Delegated Report

Householder Planning Application

Planning Application No: 20221317

Location: Crantock House 22A Old Road East Gravesend Kent

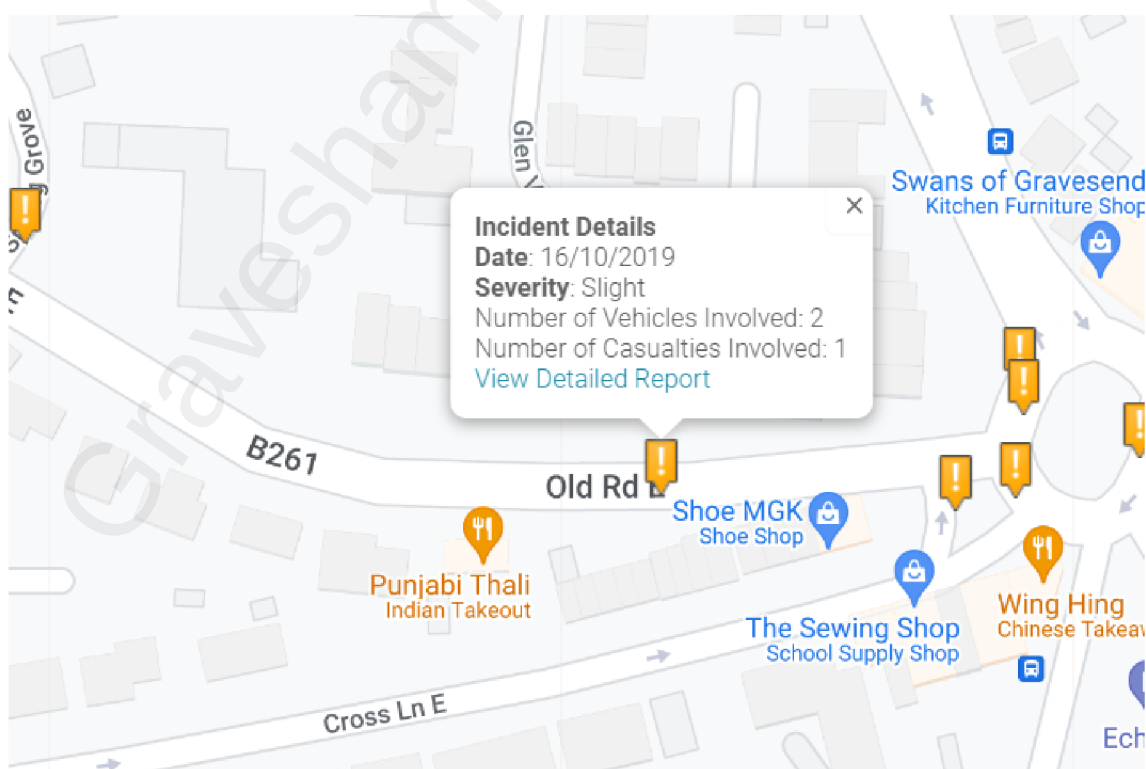
Old Road East forms part of the B road network which forms a by-pass around the town

Looking at crashmap there is a limited injury accident record in the area for the period 2017 to 2021, with a single accident to the east in 2019

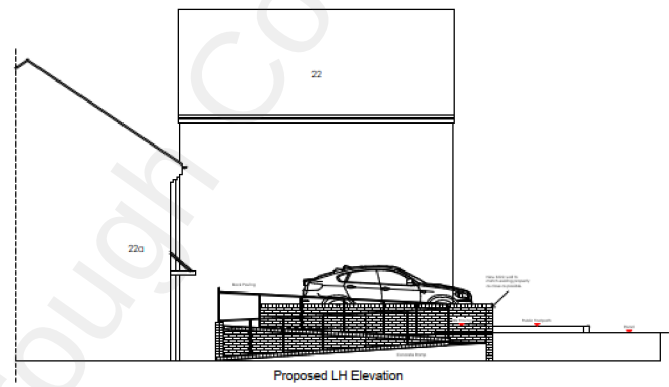
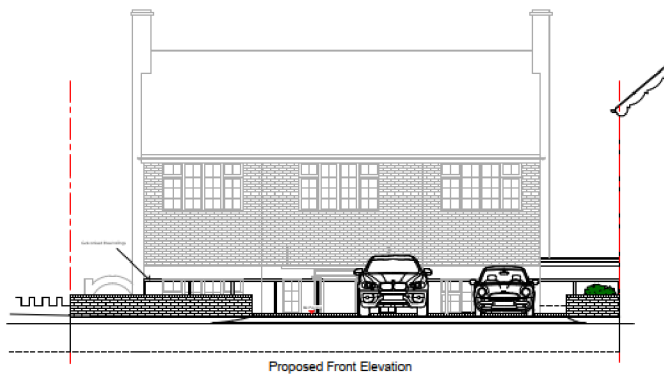
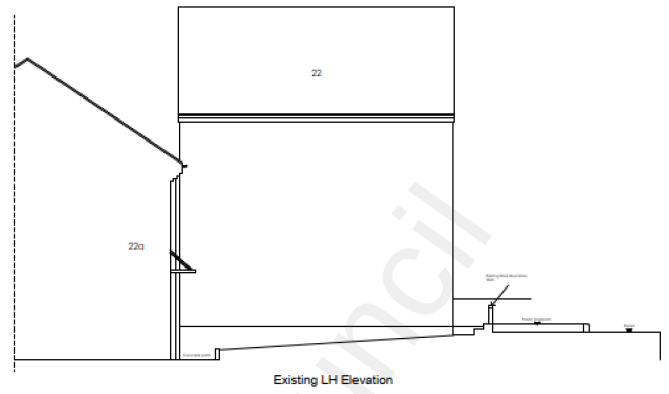
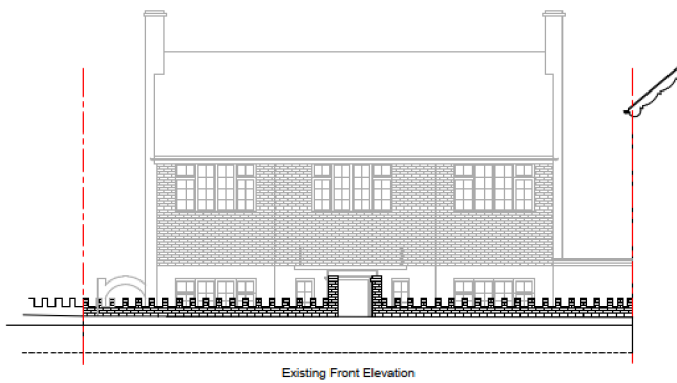
Whilst other properties within the vicinity have similar arrangements – albeit with more soft landscaping, the extensive removal of soft landscaping will add to the urbanisation of the streetscape. Such development results in a harsh developed appearance and results in a car dominated area which diminishes the positivity which soft landscaping provides.

Furthermore the levelling of the garden will result in a raised section of hardstanding. It is accepted that the application property is set below the highway and so its visibility is already slightly obscured, however the increased height of the hardstanding will hide a vast amount of the ground floor level attractive frontage and replace it with a harsh hardstanding and parked cars.

The loss of biodiversity and the impact of the hardstanding including the raising of its height will harm the character and appearance of the property and wider streetscene.
